**FINAL DRAINAGE REPORT
FOR
STERLING RANCH FILING NO. 2**

Engineering Review

**May 2020
Project No. 25188.01**

PCD File No. SF-1820 **SF-20-015**

DRAINAGE MAP
 STERLING RANCH FILING 2
 JOB NO. 25188.01
 5/15/20
 SHEET 5 OF 6

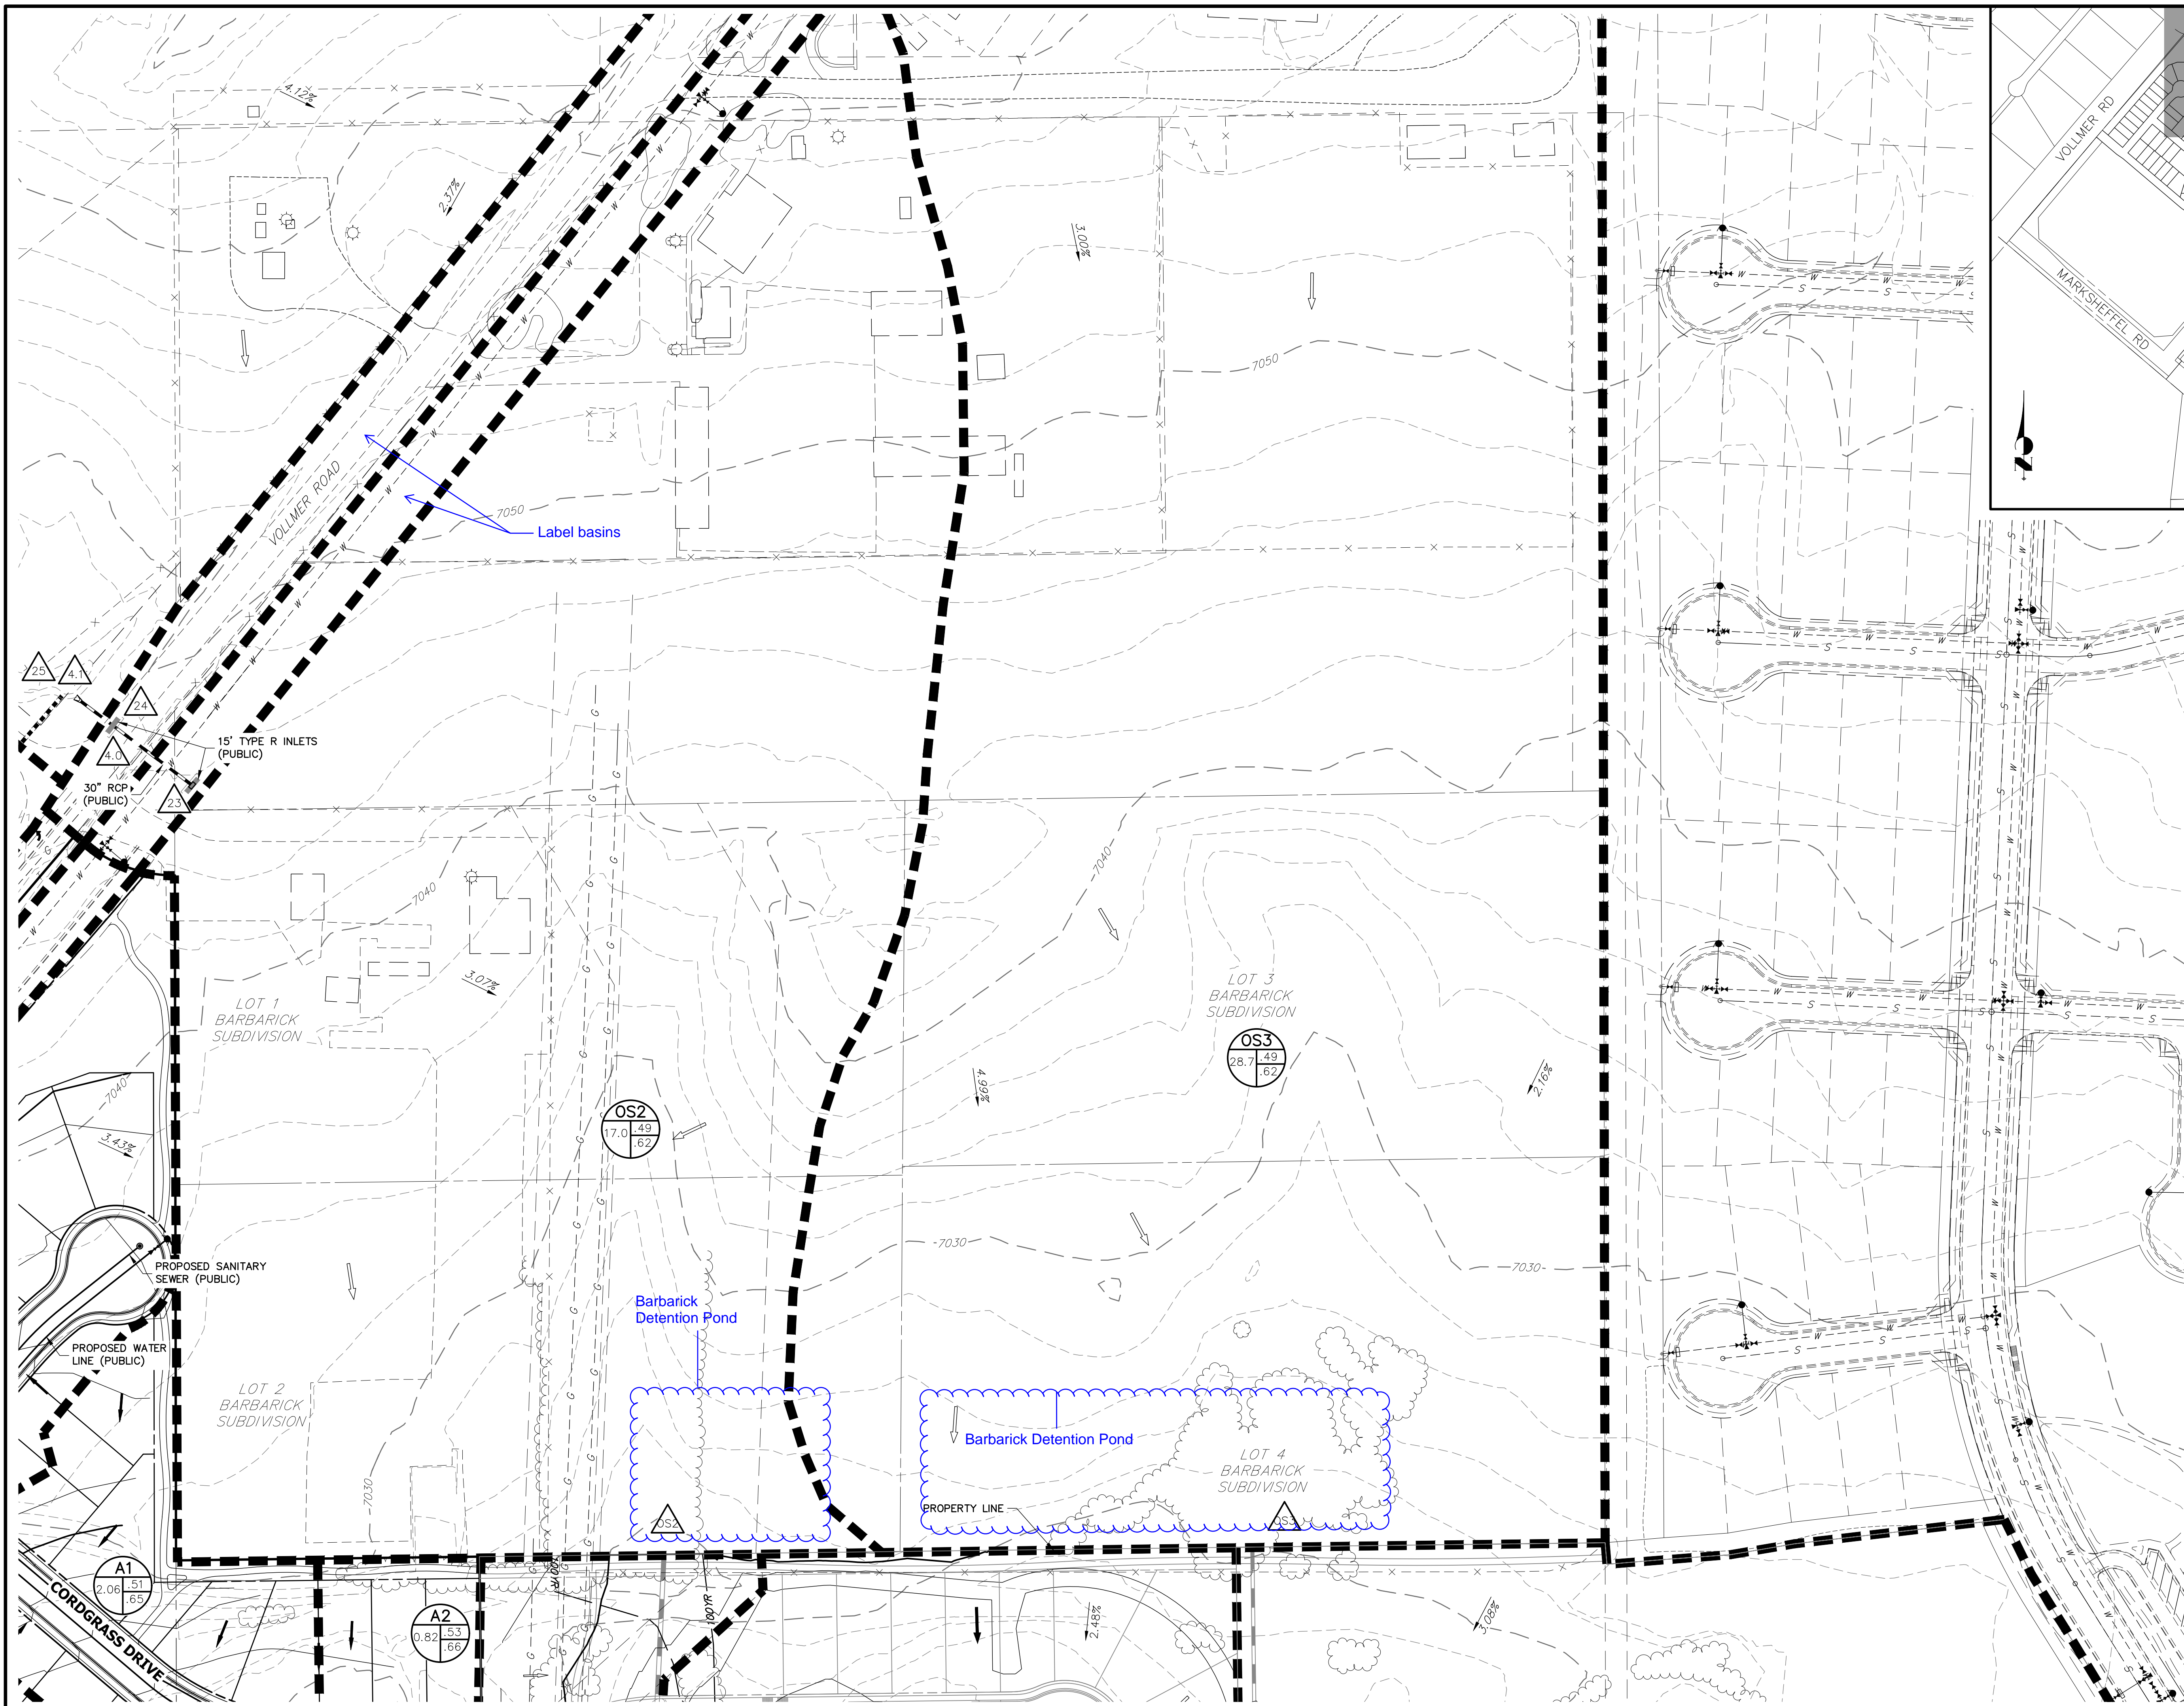
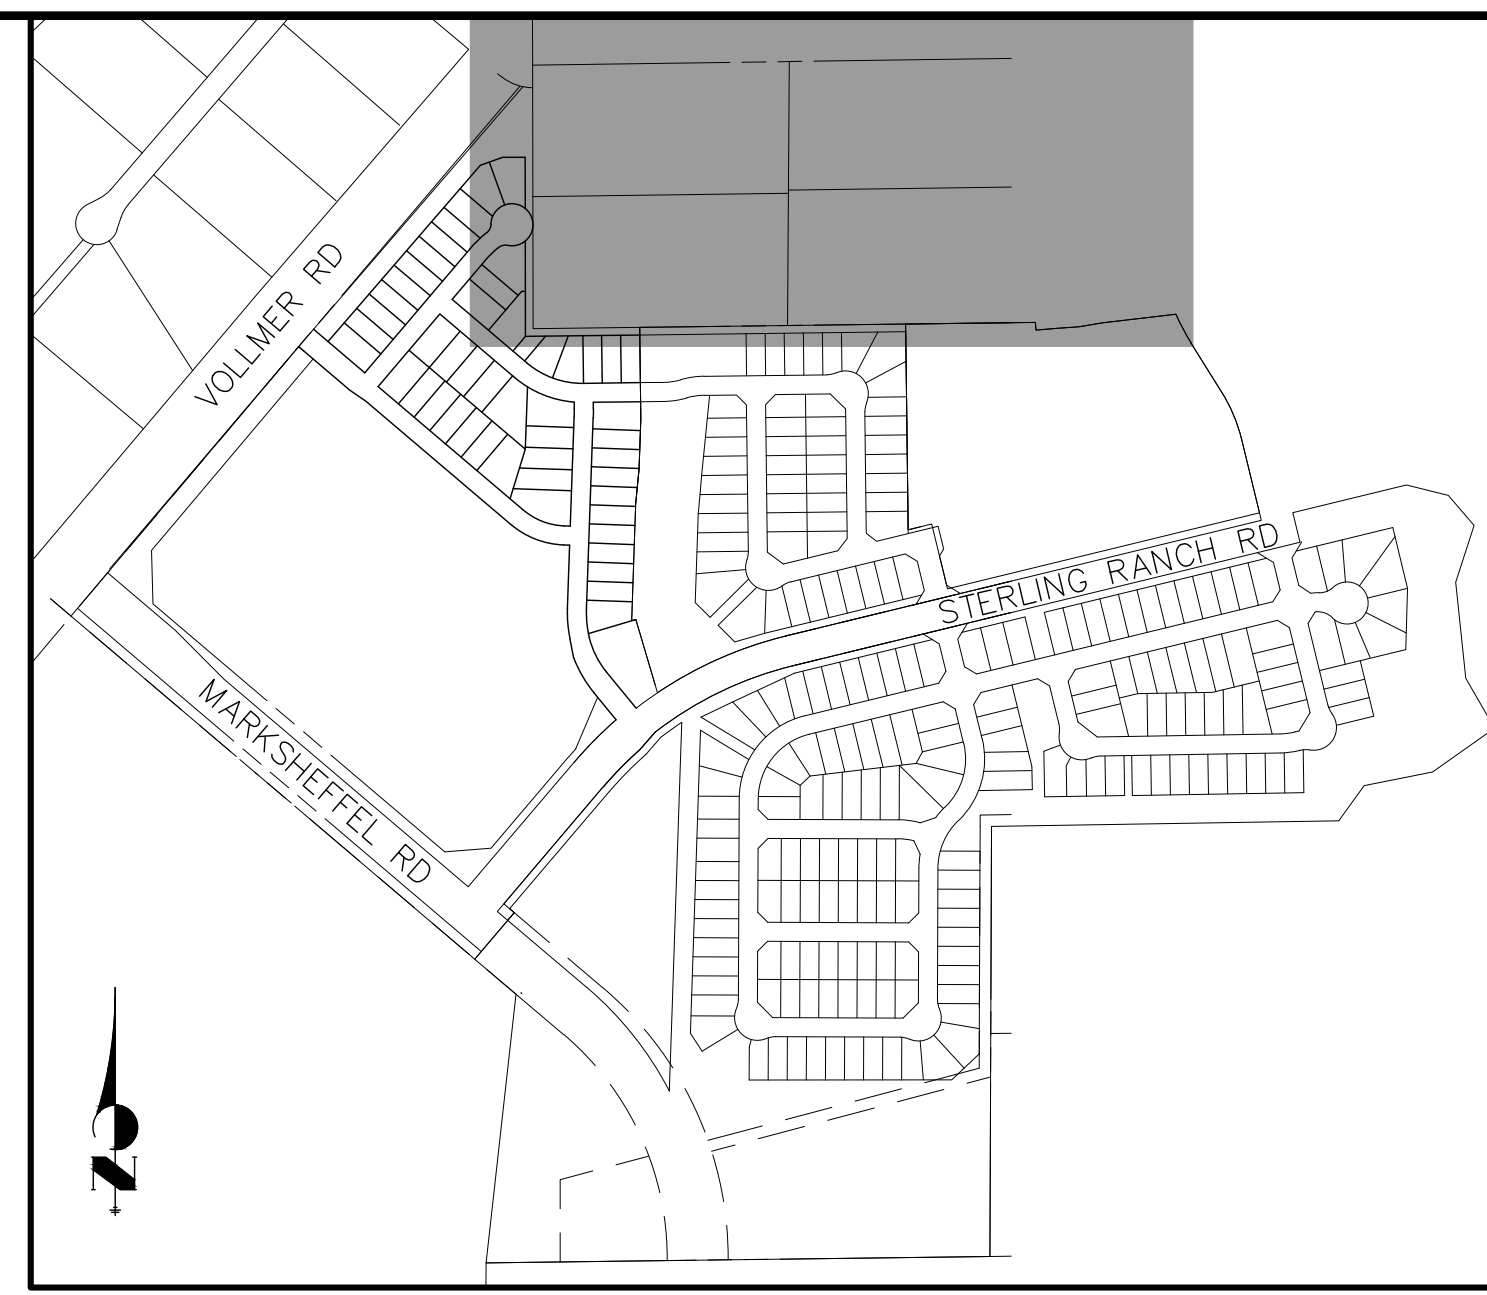
adjust label
